Our Reference: RHC-24-155-TN (Please quote in all correspondence).

Transport Note: Barnhills Farm, Merrylees Road, Thornton, Coalville
(Application Number: 24/00657/FUL)

Substantive response of the Local Highway Authority to a planning consultation received under The Development Management Order.

Planning Application Number: 24/00657/FUL

Image 1: Staff Parking Spaces

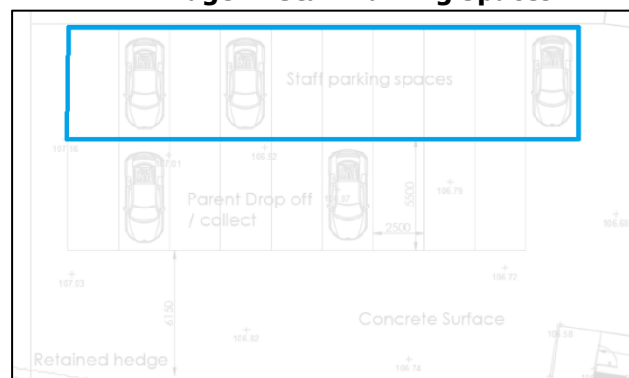
As per the LHAs previous response dated 17 September 2024 HA would not support the use of tandem parking to support the user type being applied for.

The LHA would query how the Applicants intend to manage these spaces and highlight that should the tandem spaces be used by staff, this could require multiple staff to leave the building in order to move cars which may neither be appropriate or practical.

Staff parking will be allocated to the northernmost 10 spaces, highlighted in blue in Image 1. Staff will arrive before the start of the day and leave after all children have departed, ensuring the maximum number of drop off spaces are available during operational hours. The nine spaces directly south of the staff parking will be designated for short-term parent drop-offs and collections, ensuring no instances of staff vehicles being blocked by other staff members.

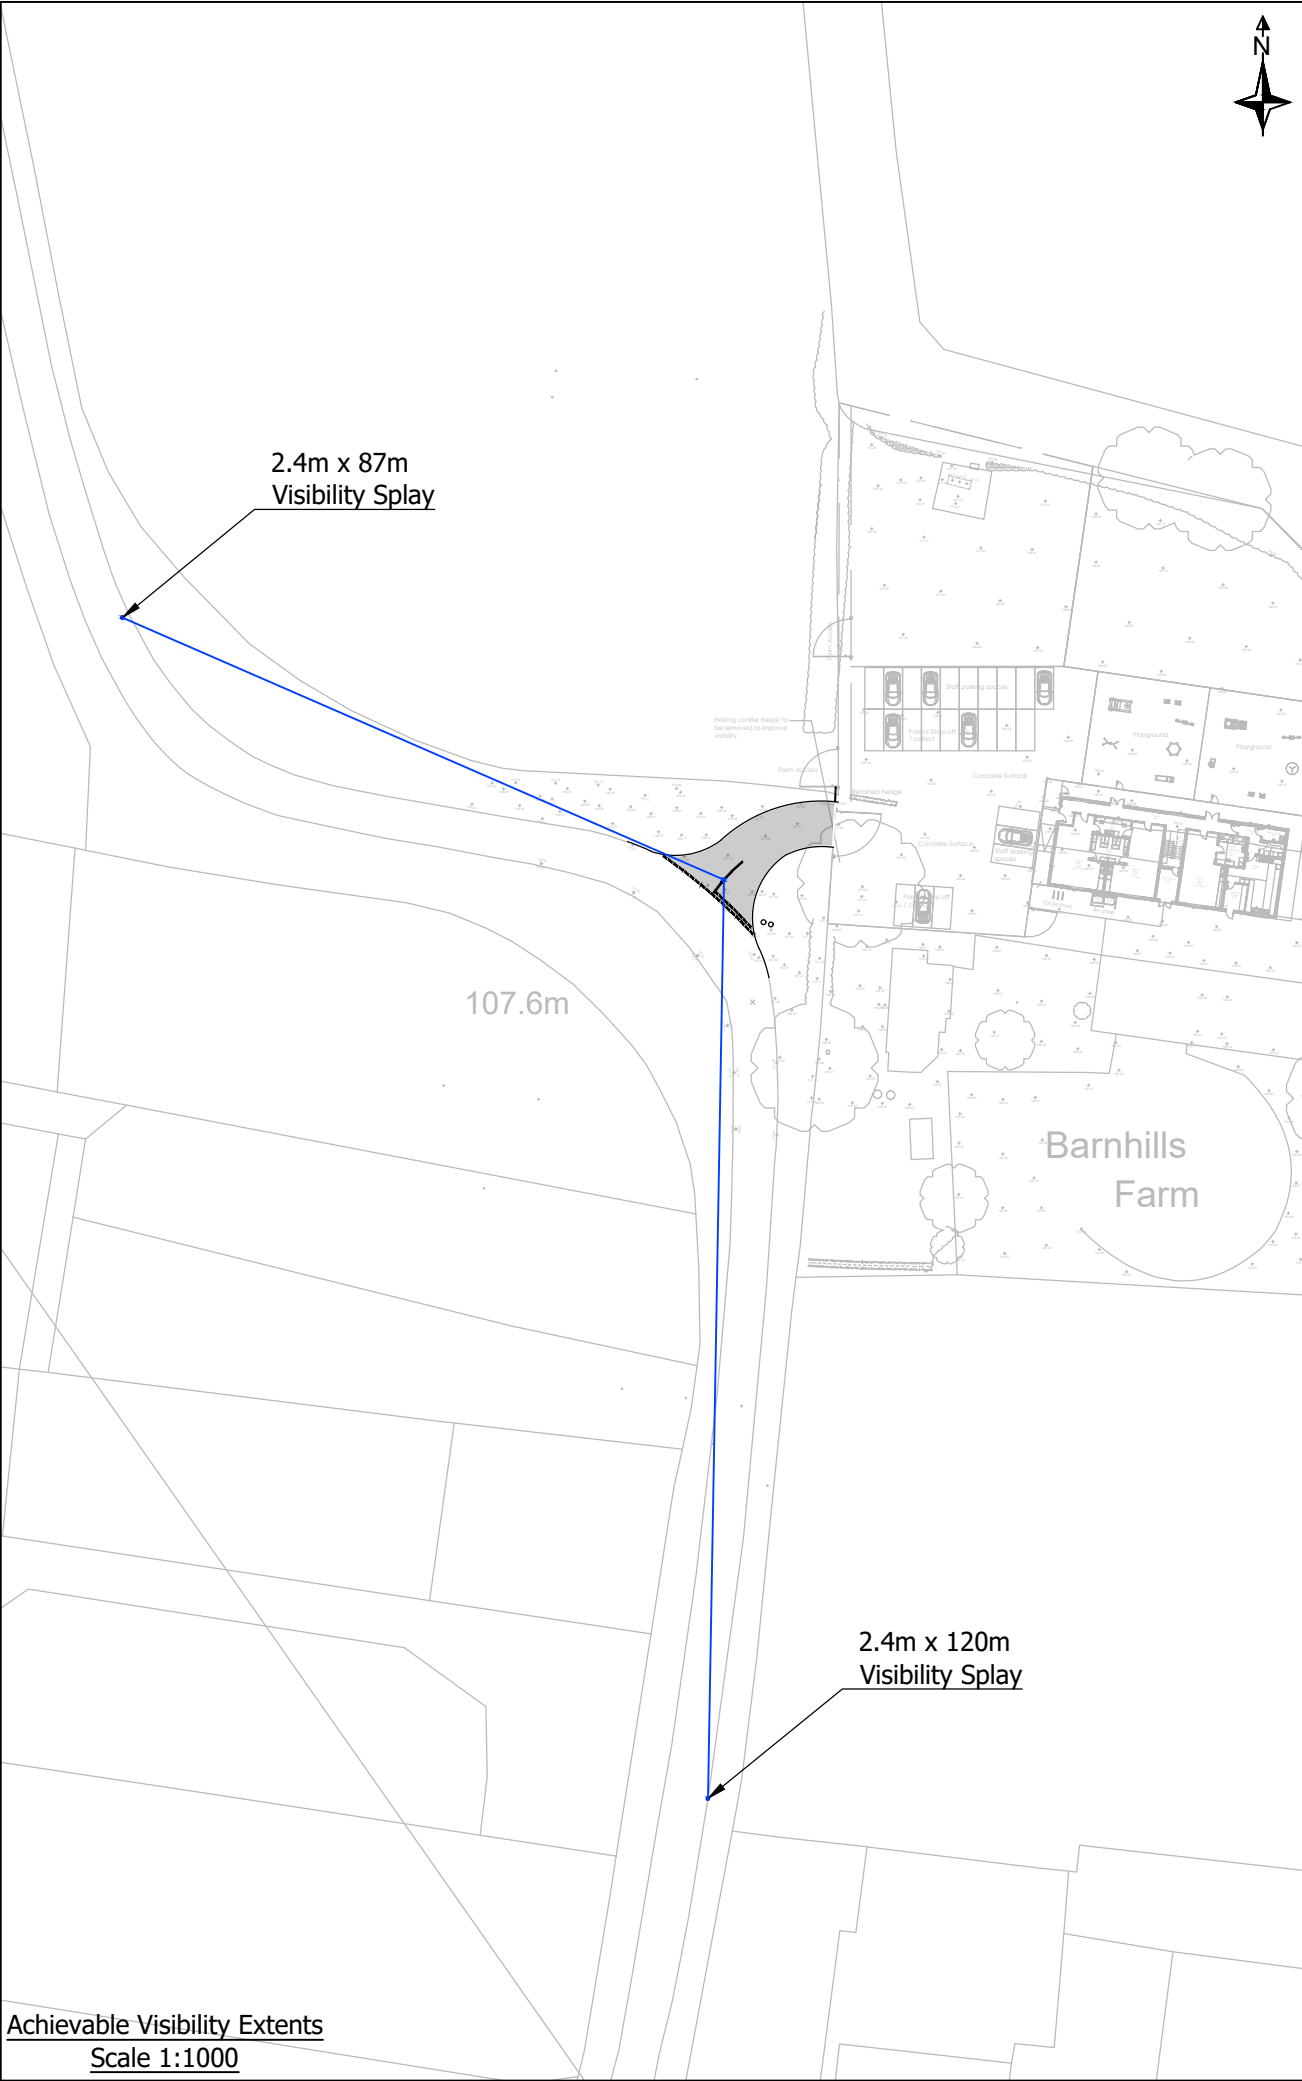
In addition, tracking has been provided to demonstrate that a tractor and trailer can safely access and egress the site. However, the LHA highlights that the submitted Swept Path Analysis (Farm Vehicle) drawing number RHC-24-155-04 revision A shows conflict points between the tracked vehicle and the proposed gate which indicated this manoeuvre would not be possible.

No details have been provided in relation to the retained farm movements on the site. These should be provided along with tracking drawings to demonstrate that these vehicles will be able to manoeuvre around the site, without impacting on the proposed parking layout.

Agricultural vehicles associated with the farm will access the site from the highway and proceed to the existing agricultural access located to the east, where these vehicles are stored. If access to the northwestern parcel of land is required, vehicles will travel from the eastern boundary into the field via a new agricultural access, without entering the highway. These routes are detailed on Drawing RHC-24-155-04b, included in **Appendix B**.

There will be no need for agricultural vehicles to access the northwestern field directly from the highway, as all surrounding land is owned by Barnhills Farm. As noted, farm vehicles are stored on the eastern side of the application site.

Agricultural movements from the site are expected to be minimal, with only around six movements occurring annually. To avoid interference with peak nursery hours, these movements will be restricted to between 10:00 and 15:00, outside the times for parent drop-offs and collections. Additionally, most agricultural activities will take place on weekends when the nursery is not in operation.

Drawing Number: RHC-24-155-01

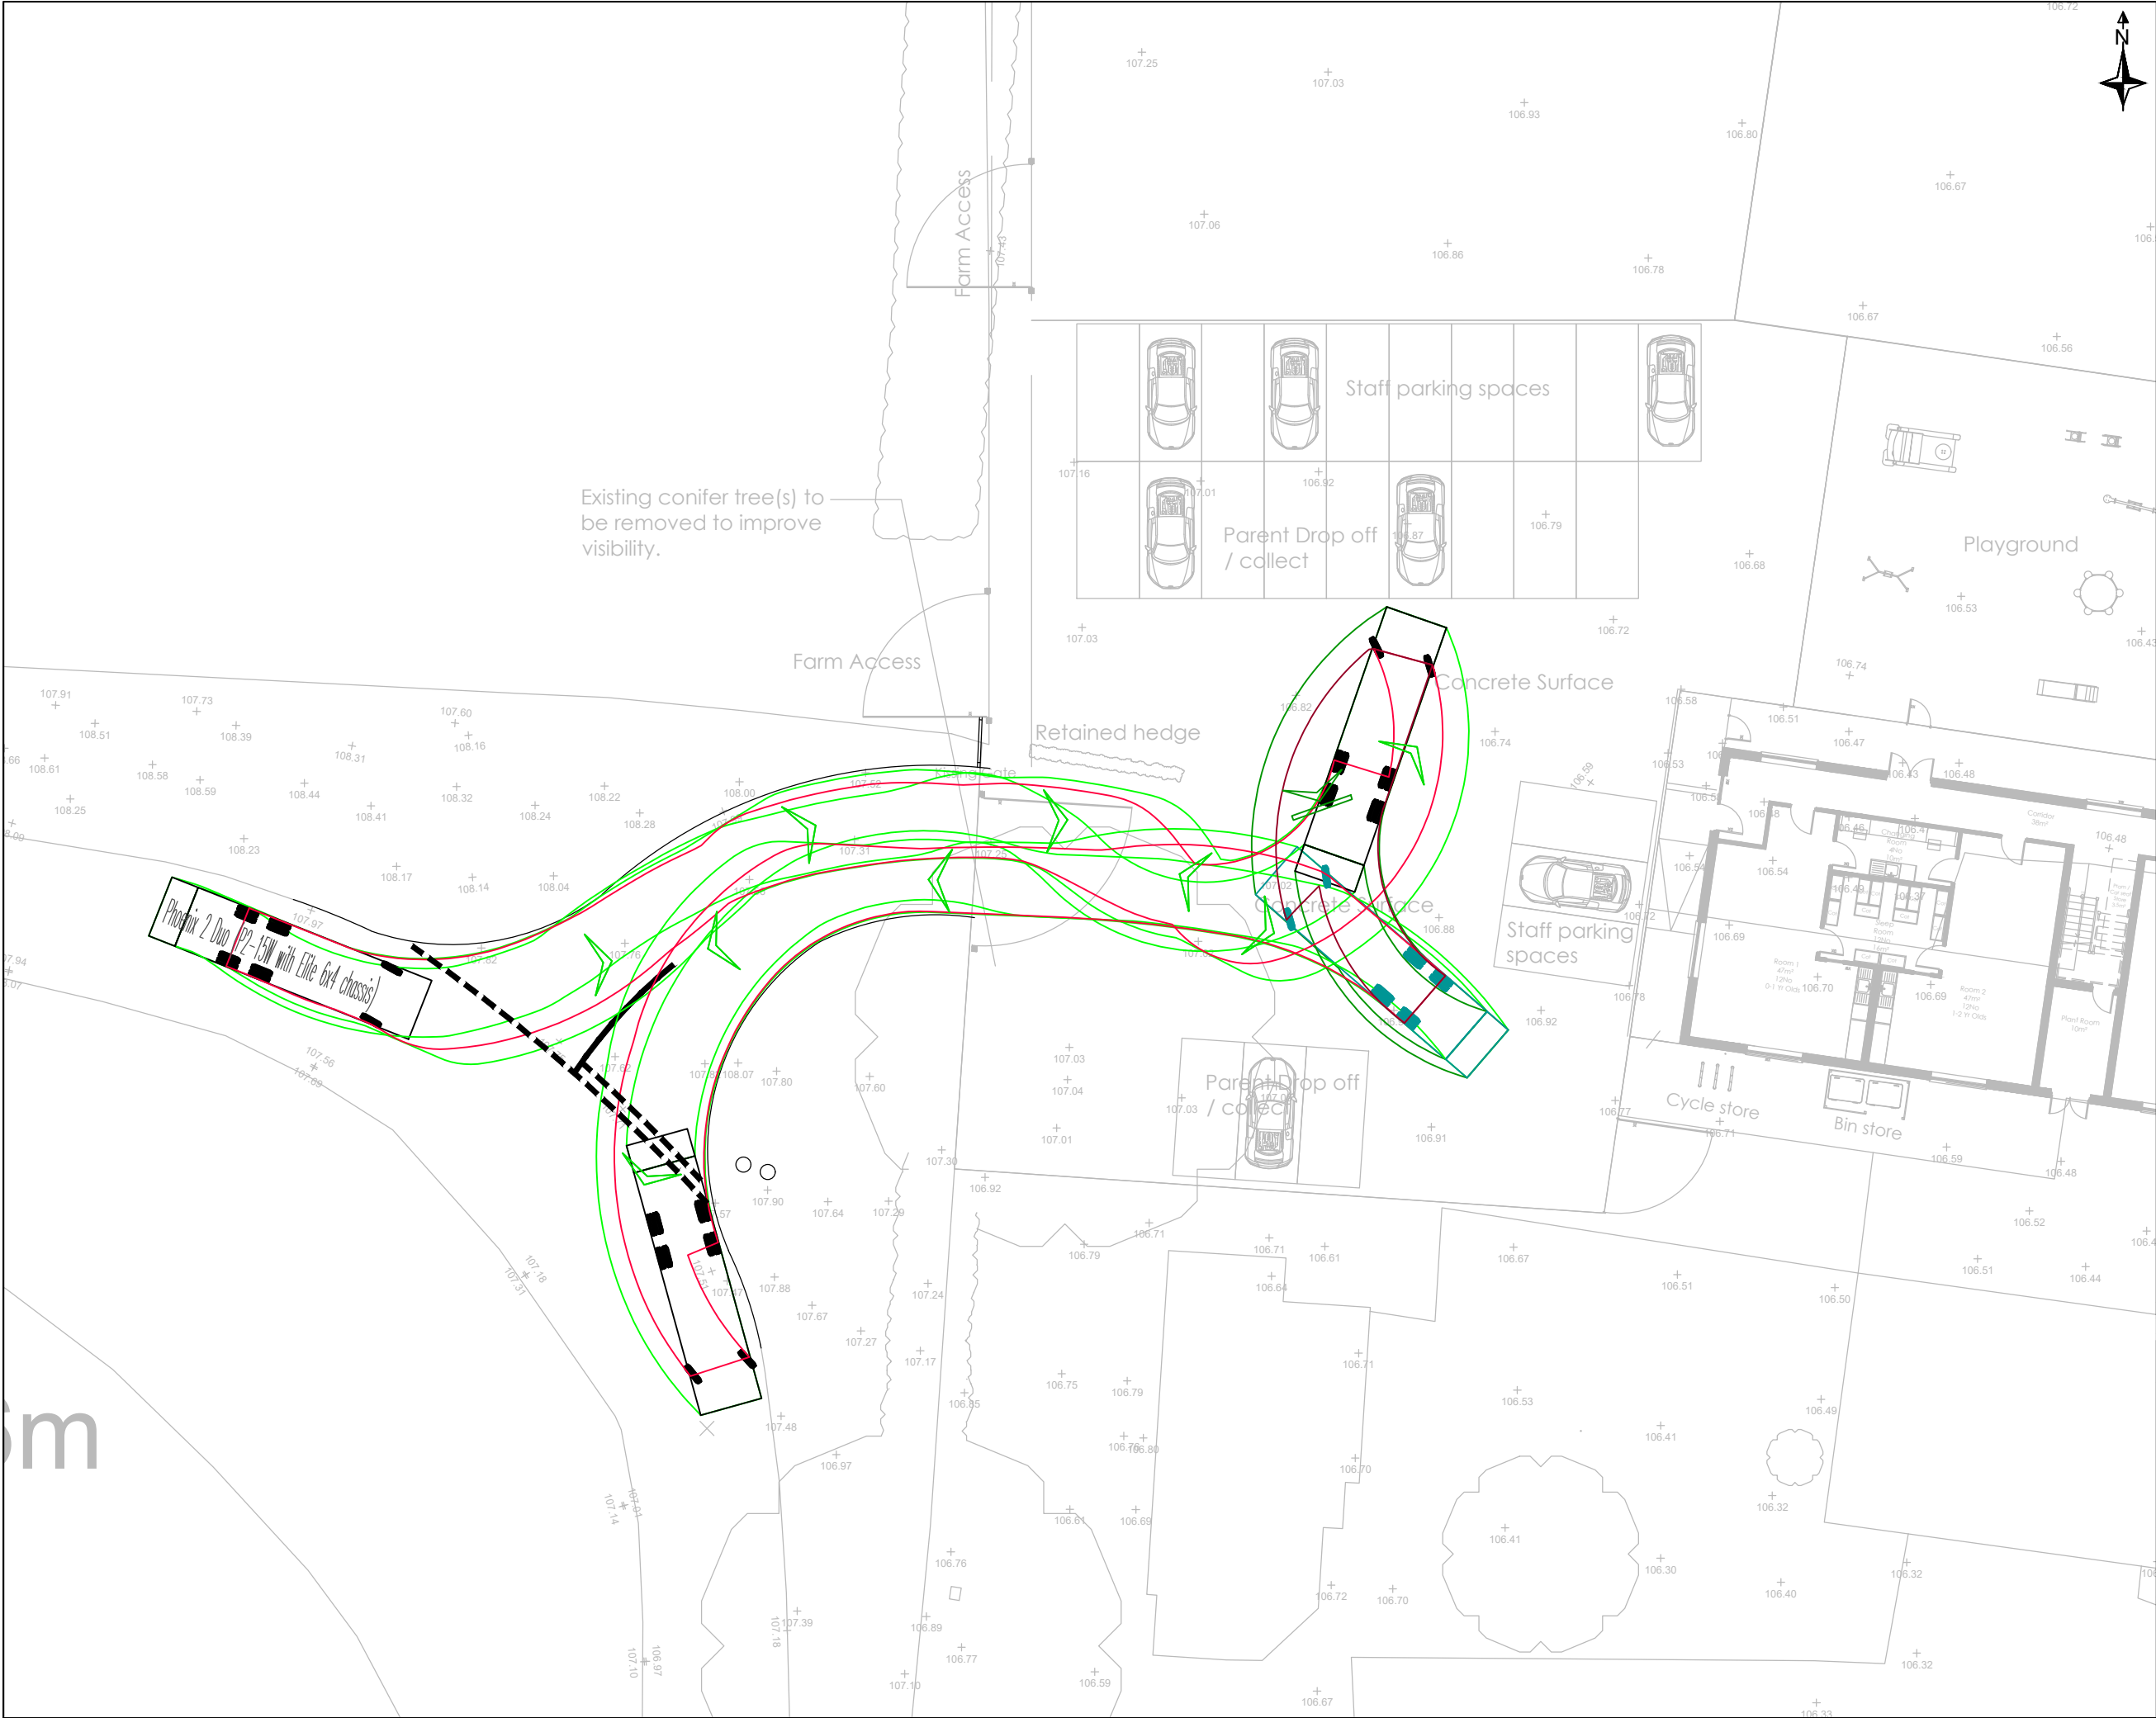
The LHA note that Access Alterations drawing number RHC-24-155-01 revision A details visibility splays of 2.4m by 43m can be achieved at the proposed bell mouth junction. Whilst this would be sufficient for 85th percentile speeds of 30mph, no evidence has been submitted that the recorded 85th percentile speeds in this location are 30pmh or below.

As per the LHA's previous advice, visibility splays should be provided in accordance with Table DG4 of the Leicestershire Highway Design Guide (LHDG) to cater for the measured 85th percentile speeds. The LHA would advise the Applicant's to carry out an Automatic Traffic Count at the site access to establish the recorded 85th percentile speeds in this location.

However, the LHA are concerned that there is insufficient space available on the diverted access between the proposed site access and neighbouring field for this to be installed. Therefore, the request a revised drawing is provided to demonstrate an adequate facility can be provided and will not be restricted in width by the proposed access.

Drawing Number RHC-24-155-01b, attached within **Appendix C**, outlines the achievable visibility splays from the site access, with these splays contained solely within land under the control of the Highway Authority.

The visibility splays extend 87 metres to the west of the access and 120 metres to the south. According to Table DG4 of the Leicestershire County Council Highway Design Guide (LHDG), these distances are adequate for 85th percentile vehicle speeds of up to 40mph to the west and 44mph to the south of the access.

Given that the road adjacent to the site is subject to a 30mph speed limit, it would be unreasonable for the Highway Authority to require a speed survey. The achievable splays are sufficient for speeds exceeding the posted limit by more than 10mph. Furthermore, the meandering nature of the highway adjacent to the site would naturally result in lower vehicle speeds and therefore, given the site-specific circumstances, the visibility splays presented on Drawing Number RHC-24-155-01b can only be considered suitable by the Highway Authority.

In regards to the kissing gate proposed along the Right of Way (RoW), a minimum two metre width will be

safeguarded for RoW users, as shown on Drawing Number RHC-24-155-01b.

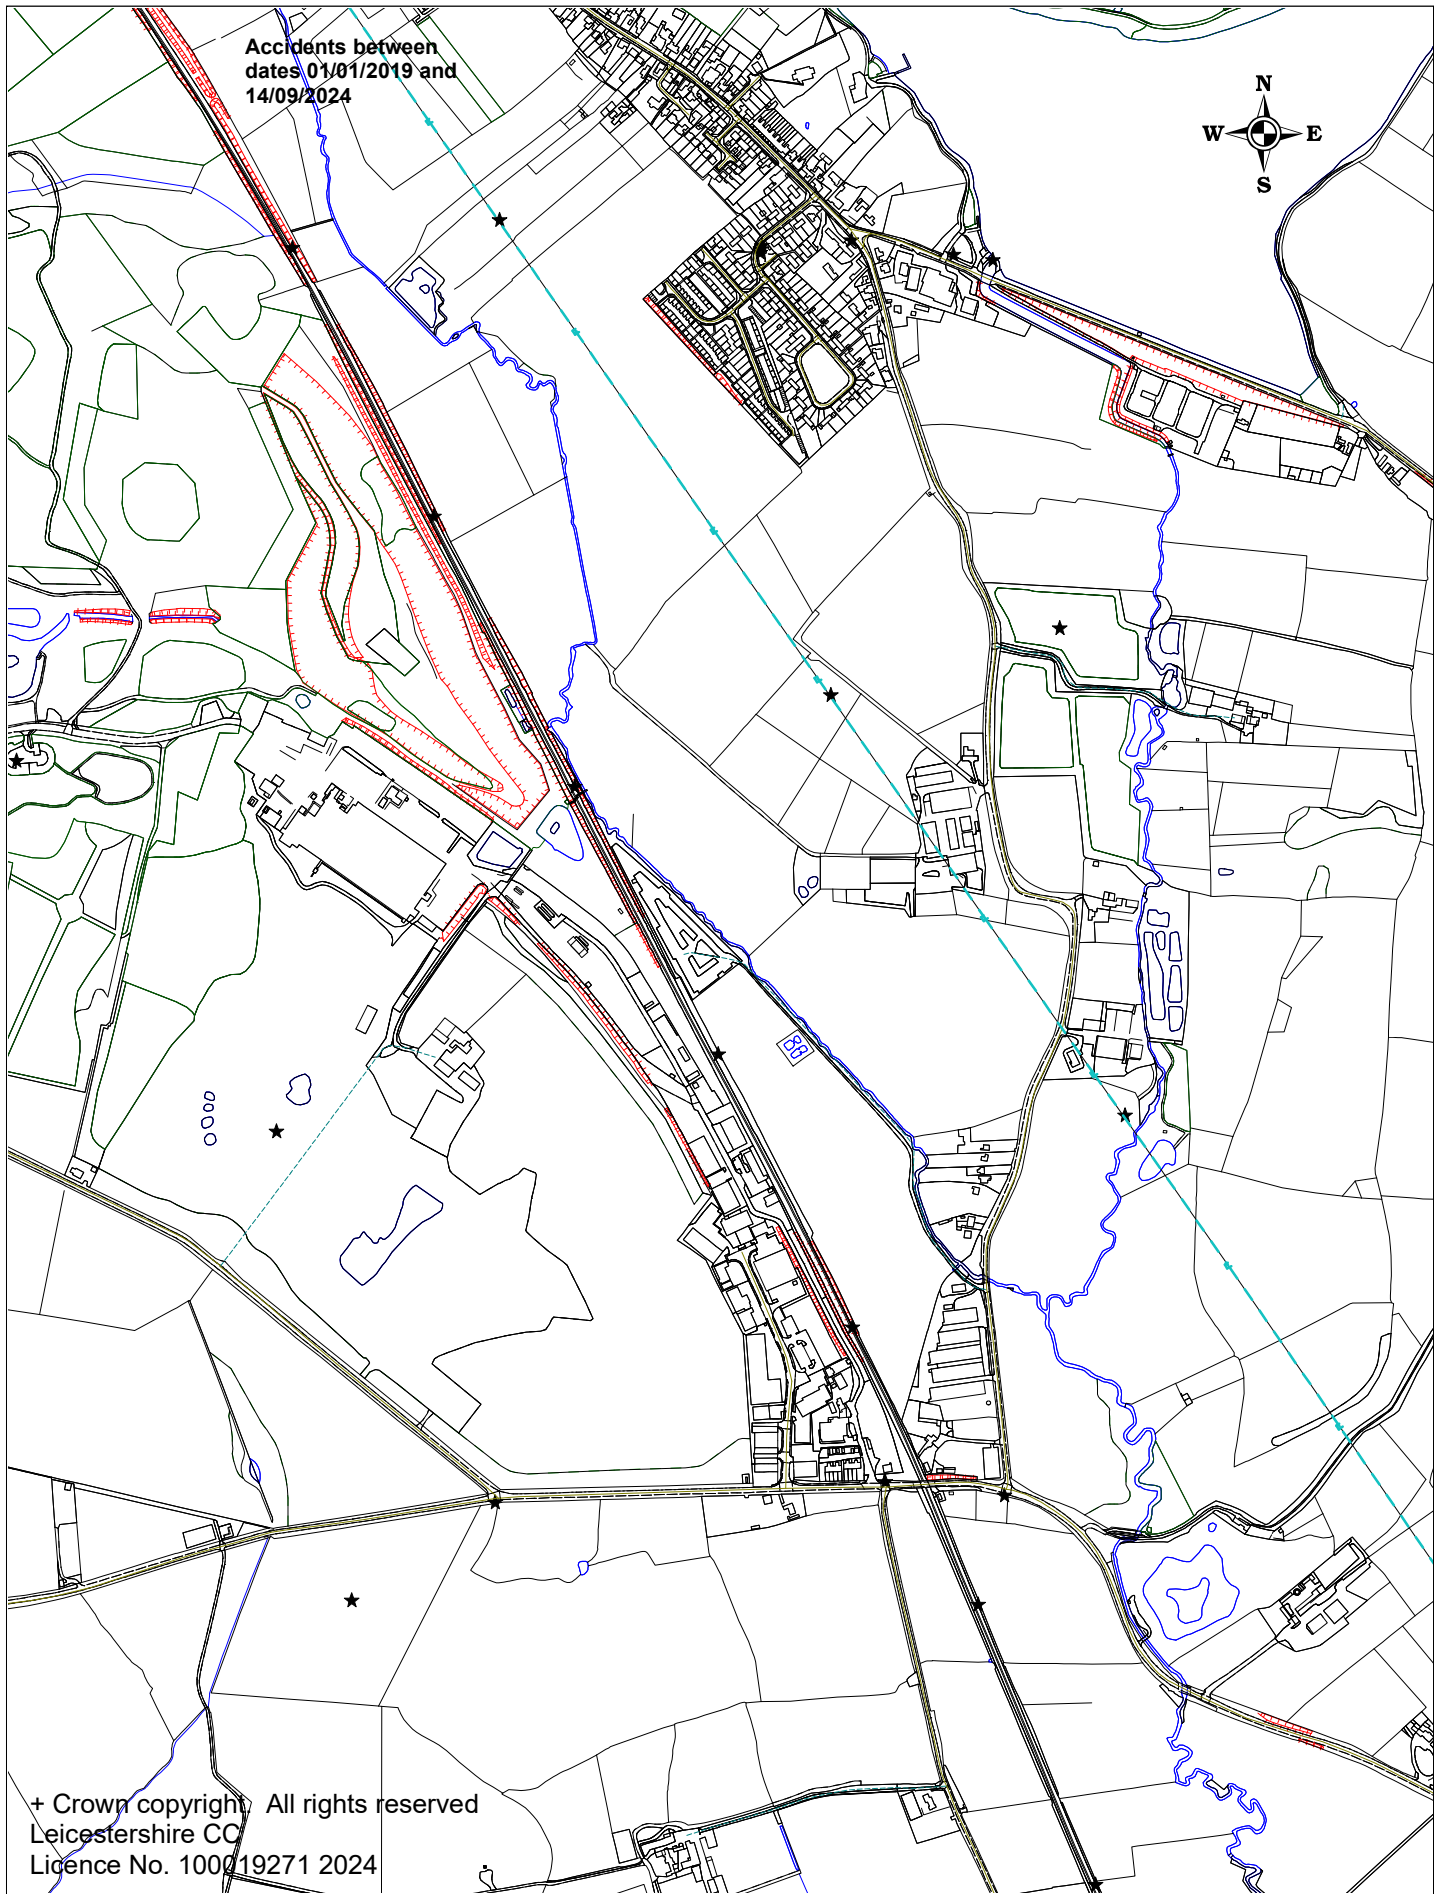
The LHA note tracking drawings have been provided to demonstrate a refuse vehicle is able to access and egress the site. This is shown on Swept Path Analysis (Access) drawing number RHC-24-155-02 revision A. In addition, tracking drawings have been provided to demonstrate a refuse vehicle is able to turn within the site to enable the vehicle to exit the site in a forward gear.

However, the LHA have compared the two documents and highlight that the swept path analysis for the access and egress is a separate exercise to the swept path analysis of the vehicle manoeuvring within the site. The LHA are concerned that different angles of access and egress have been shown on the different exercises and where the tracking appears tight in places, may result in the manoeuvres not being possible.

A single swept path analysis drawing has been undertaken showing the council's refuse vehicle entering, turning and exiting the site within a forward gear (see **Appendix D**).

As it is no longer proposed that an agricultural access will be taken from the highway, no further swept path drawings are necessary.
